ORDINANCE NO. 3943

AN ORDINANCE OF THE CITY OF MESQUITE, TEXAS, AMENDING CHAPTER 5 OF THE CODE OF THE CITY OF MESQUITE BY DELETING ARTICLE XIII IN ITS ENTIRETY AND ADDING A NEW ARTICLE XIII THEREBY ADOPTING THE INTERNATIONAL RESIDENTIAL CODE, 2006 EDITION, AND PROVIDING CERTAIN ADDITIONS AND DELETIONS THERETO; PROVIDING FOR A REPEALER CLAUSE; PROVIDING FOR A SEVERABILITY CLAUSE; PROVIDING FOR A PENALTY NOT TO EXCEED TWO THOUSAND (\$2,000.00) DOLLARS FOR EACH OFFENSE; AND DECLARING AN EFFECTIVE DATE.

Sec. 5-468. Amendments to the International Residential Code, 2006 Edition.

Figure N1101.2 TEXAS CLIMATE ZONES

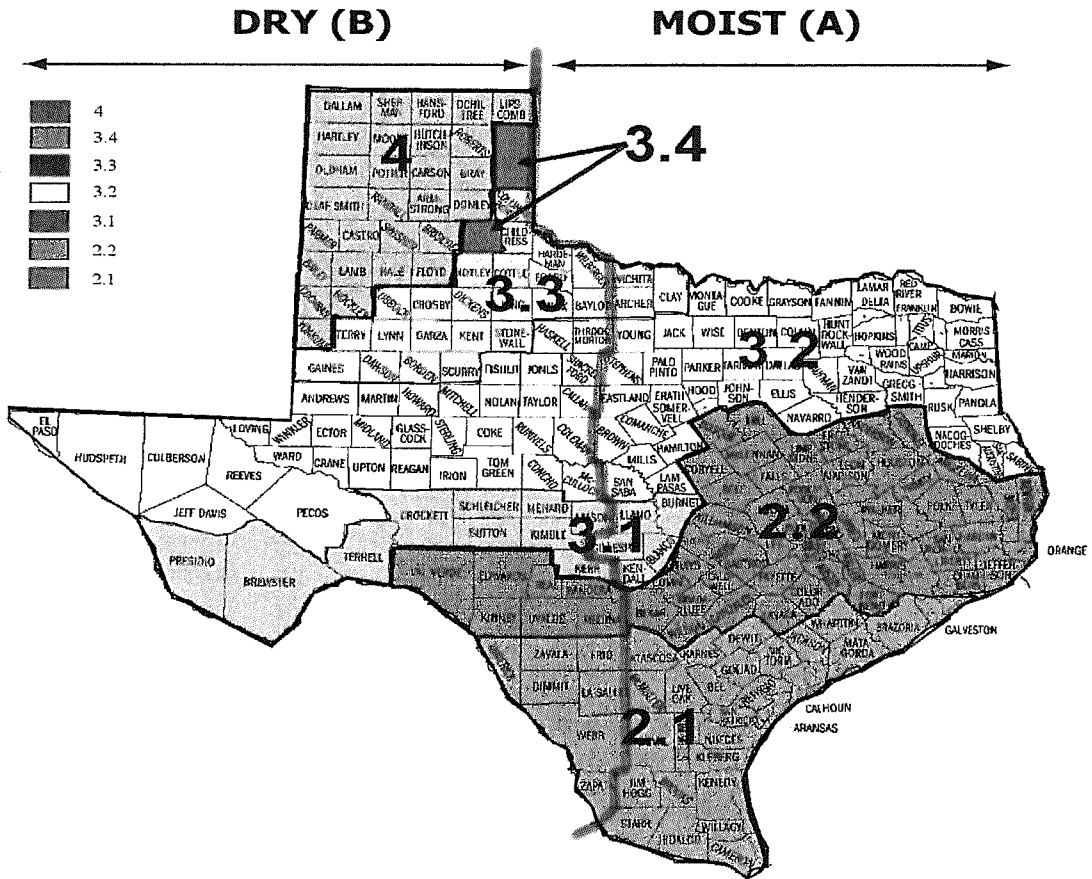
- (c) *Figure N1101.2.* Amend by deleting Figure N1101.2 in its entirety and adding a new Figure N1101.2 to read as follows:
